PIC16F62X Silicon/Data Sheet Errata

The PIC16F62X (Rev. A) parts you have received conform functionally to the Device Data Sheet (DS40300B), except for the anomalies described below.

PIC16F62X

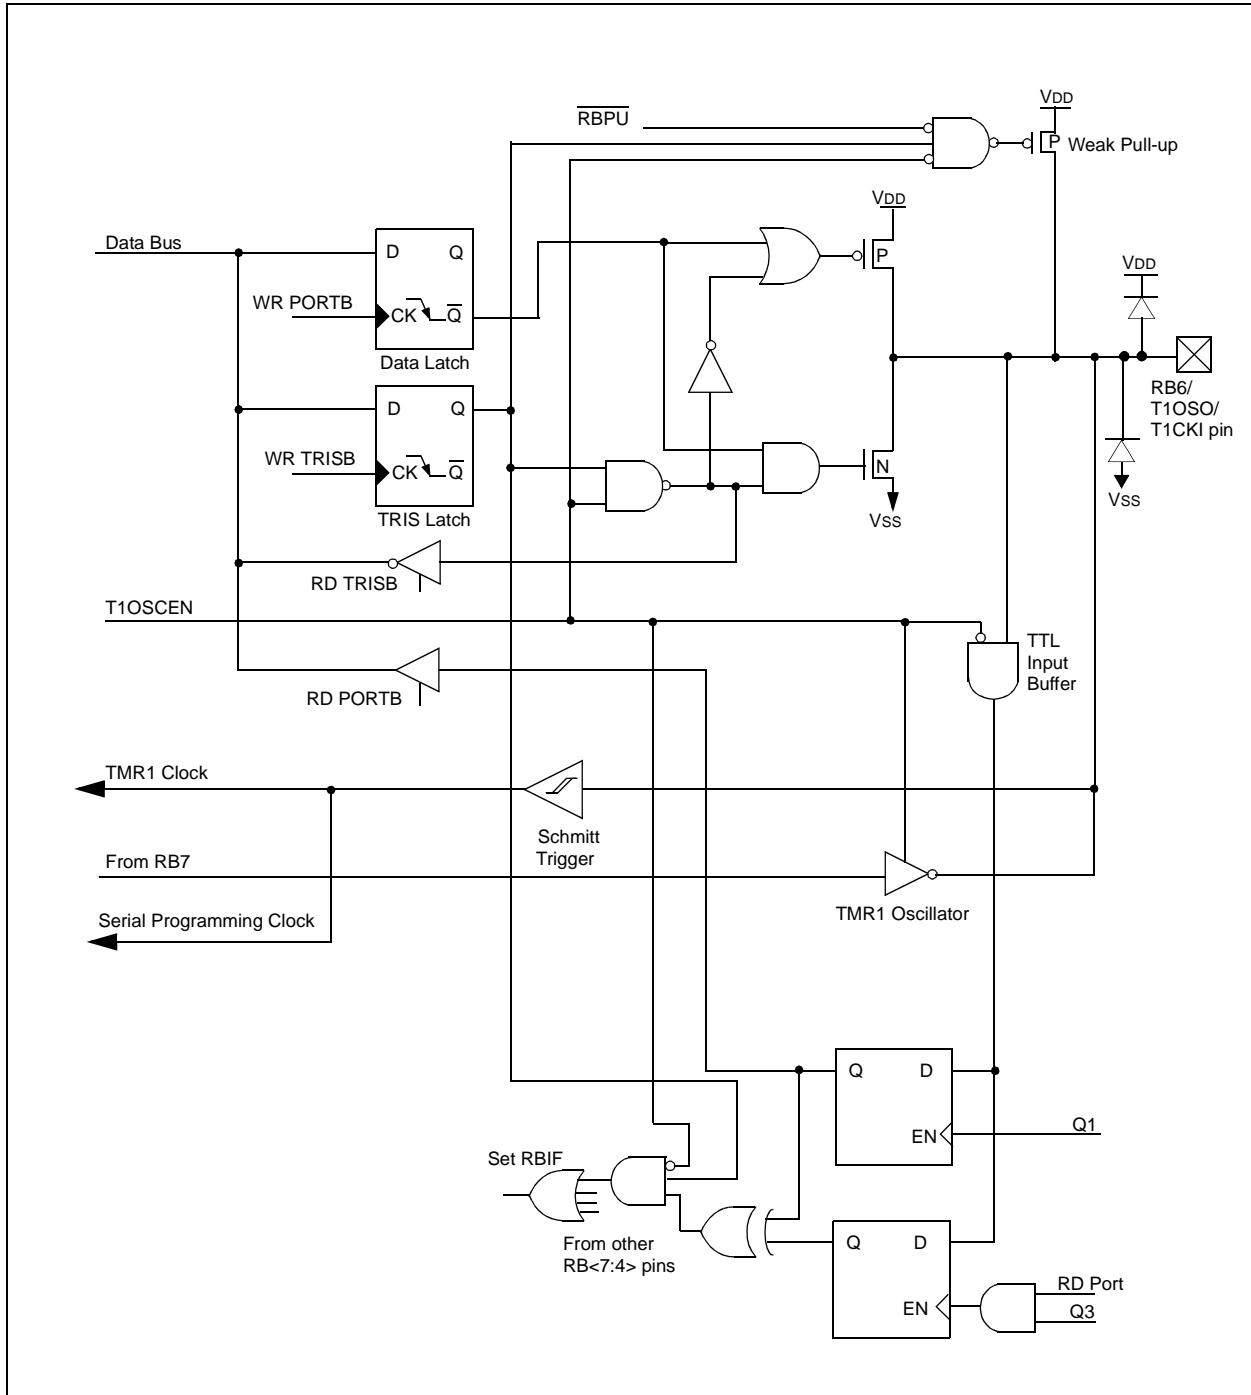
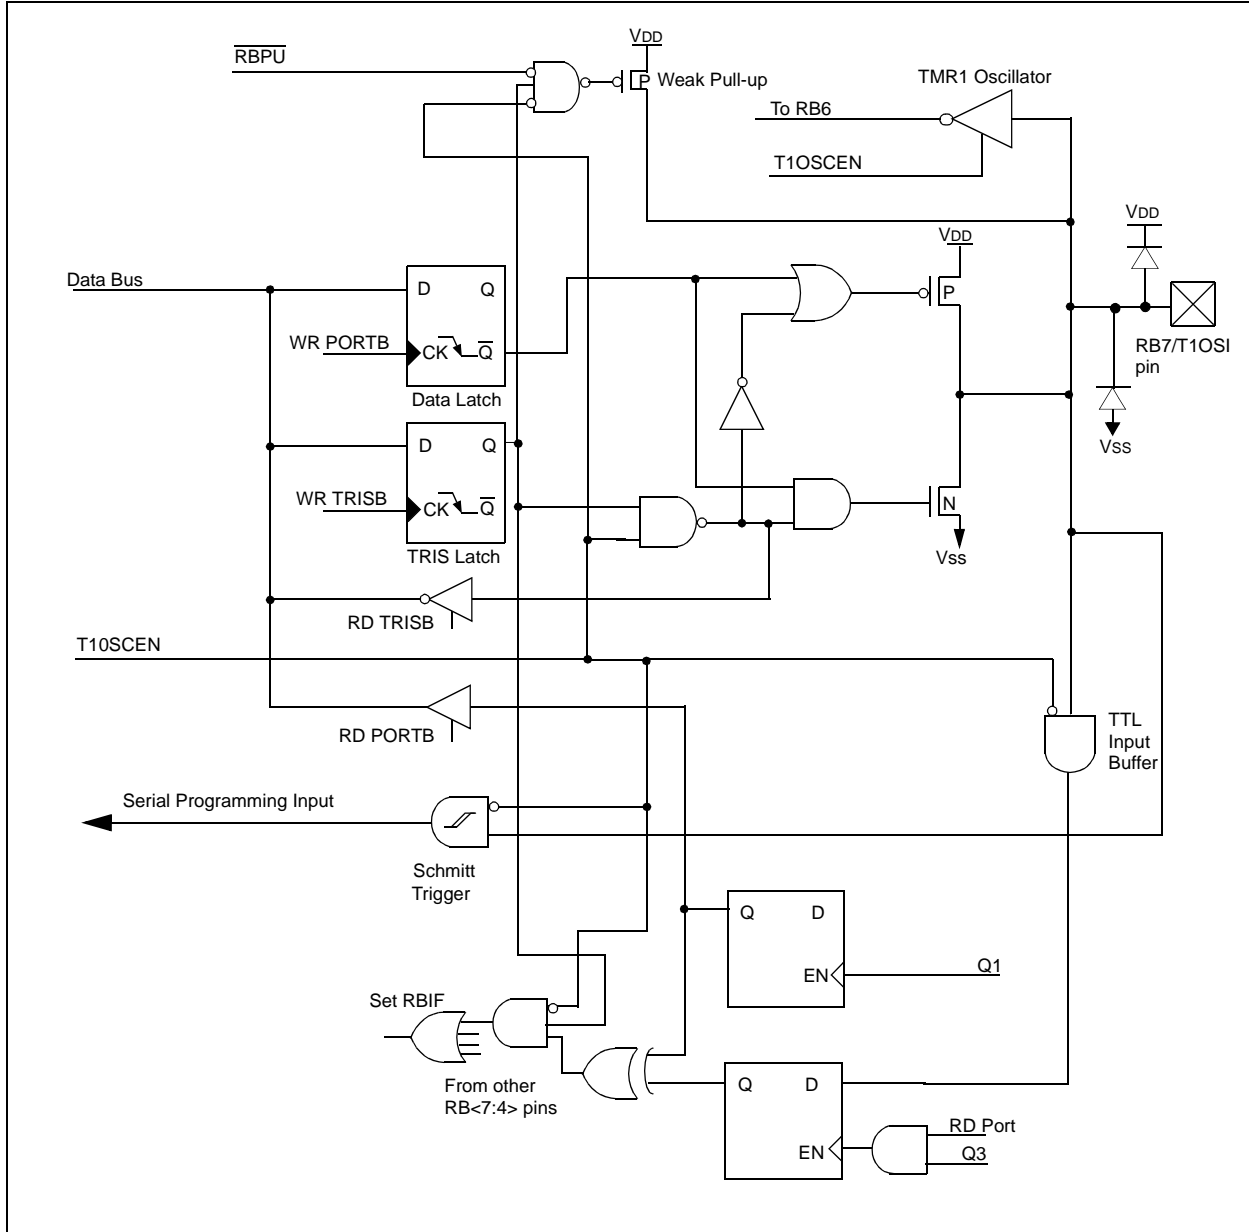
1. Module: I/O Ports

A read of the PORTB Data Direction Register (TRISB) returns the Data Direction state on the port pins themselves and not the contents of the TRISB register latch.

FIGURE 5-5: BLOCK DIAGRAM OF THE RA5/MCLR/VPP PIN

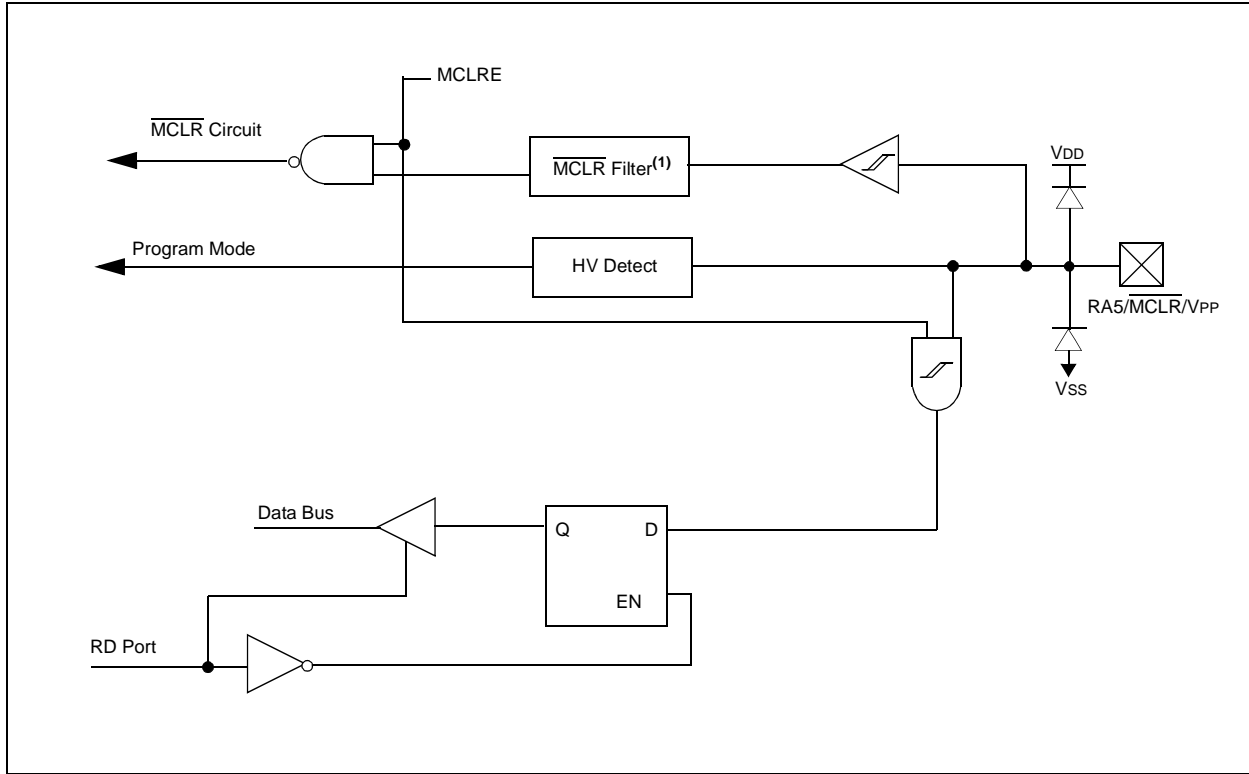
3. Module: I/O Ports (RA5/MCLR/VPP)

The following block diagram shown in Section 5, Figure 5-5 is incorrect. The following figure should be used instead.
